TECHNICAL INFORMATION

Subject ▶ Change of D-shaped Side Handle

For Models ▶ HR4000C, HR5000, HR5000K

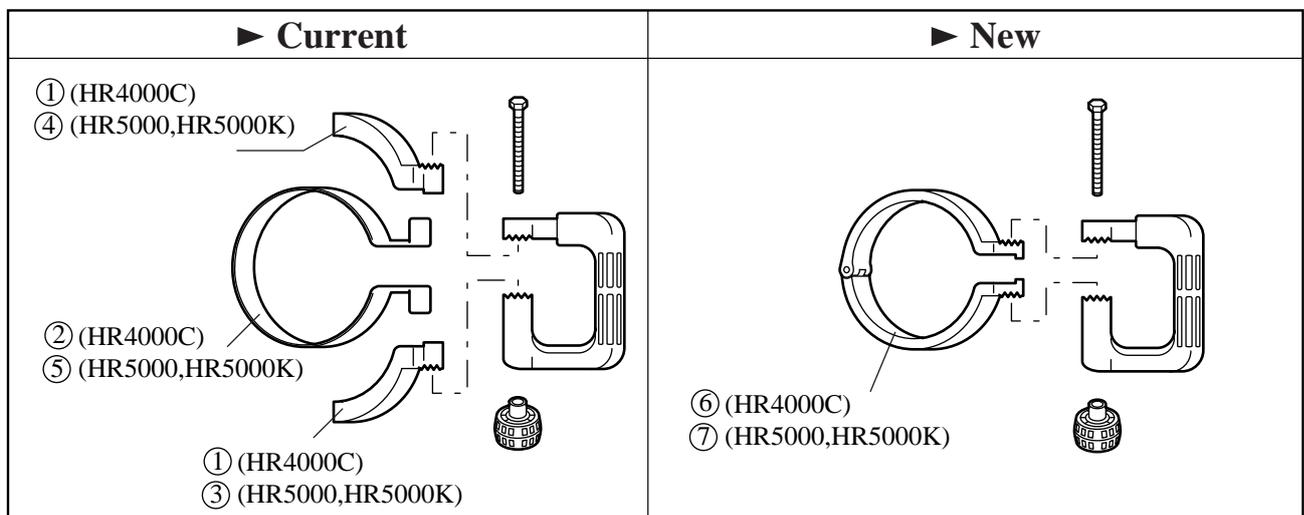
Description ▶ Side Handle Complete has been modified as illustrated below for higher durability. Accordingly, Part No. of Side Handle Ass'y which includes the side handle complete as its component has also been changed.

Model	▶ Current	▶ New	Summary of modification
HR4000C	① Side Handle Base 68 (resin)/ 2pcs. ② Handle Spring 68(steel plate)/ 1pc.	⑥ Side Handle 68 Complete (aluminum)/ 1pc.	In either case, the current parts have been unified to the handle complete.
HR5000, HR5000K	③ Lower Handle Base (resin)/ 1pc. ④ Upper Handle Base (resin)/ 1pc. ⑤ Handle Spring 62(steel Plate)/ 1pc.	⑦ Side Handle 62 Complete (aluminum)/ 1pc.

Item No.	Current part	Q'ty	I/C	New part	Q'ty	Note
126, 128	Side Handle Base 68 416298-3	2	←	Side Handle 68 Complete 151769-0	1	HR4000C Interchangeable as a set
127	Handle Spring 68 344490-0	1		Side Handle 62 Complete 151768-2	1	
121	Lower Handle Base 416481-2	1	←	Side Handle Ass'y 134886-1	1	HR5000, HR5000K Interchangeable as a set
120	Upper Handle Base 416480-4	1		Side Handle Ass'y 134887-9	1	
122	Handle Spring 62 344617-2	1				
B01	Side Handle Ass'y 134804-9	1	←	Side Handle Ass'y 134886-1	1	HR4000C
500 (B01)	Side Handle Ass'y 134797-0	1	←	Side Handle Ass'y 134887-9	1	HR5000, HR5000K
